Nalcor Energy Marketing

Presentation to the Régie de l'énergie du Québec (the "Régie")

DEMANDE DU TRANSPORTEUR RELATIVE À LA CONSTRUCTION D'UNE LIGNE DE 735 KV ENTRE LES POSTES MICOUA ET DU SAGUENAY

Régie's file: R-4052-2018

Romaine Project and the need for the Micoua-Saguenay Line

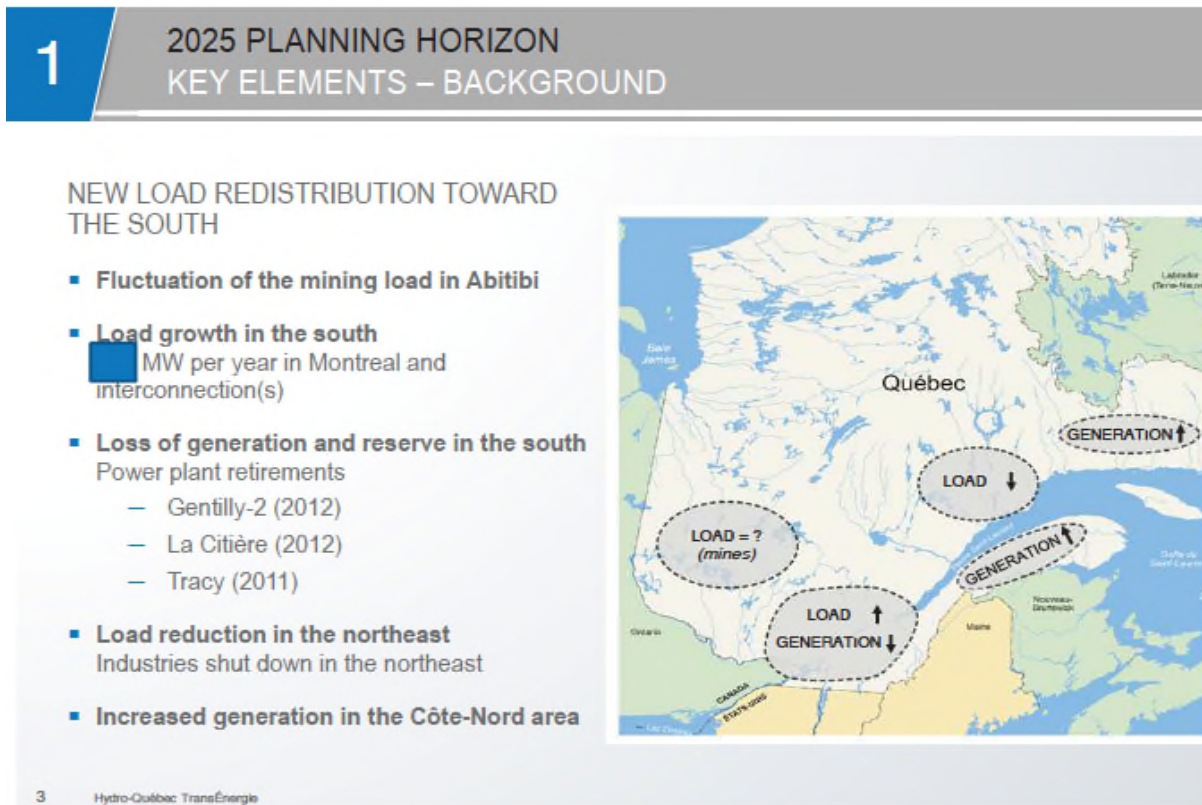
- In 2015, HQT justified the need of the Micoua-Saguenay Line by:
 - The lost of load in the Côte-Nord region
 - The increase of generation (Romaine Project)¹²

- The need for additional transmission capacity would have been reduced by 640 MW without the integration of La Romaine 3 and 4
- On December 31, 2013 (thus after HQT had received the lower demand forecast for the Côte-Nord region), the interconnection work of La Romaine 3 and 4 were at the initial stage and could thus have been delayed

Figure 1 – Projets identifiés pour l'amélioration de la sécurité du réseau face au verglas

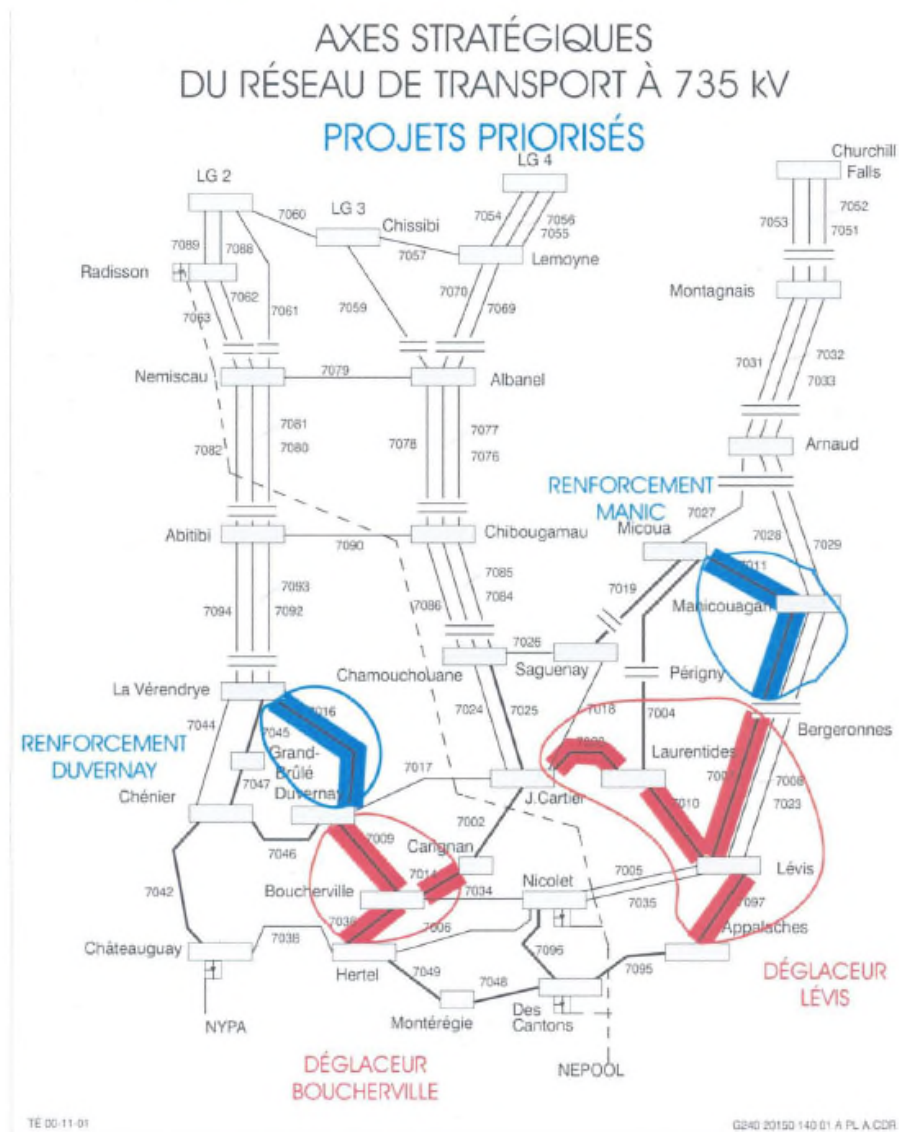
- The ice storm criteria should not be considered by the Régie in the economic analysis for the following reasons:
 - In the proceedings on the de-icing device at the Lévis substation (R-3522-2003), HQT stated that no investment was needed in the northeast region and that the focus should be on the high load areas of Montréal and Québec City

- In the event that investment should become needed in the northeast region, the required investment should be on the Micoua-Manicouagan and Manicouagan-Bergeronne paths, not the Micoua-Saguenay path

- Those criteria were not considered in the proposed investment (series compensation option) to integrate the Romaine power plants (R-3757-2011)
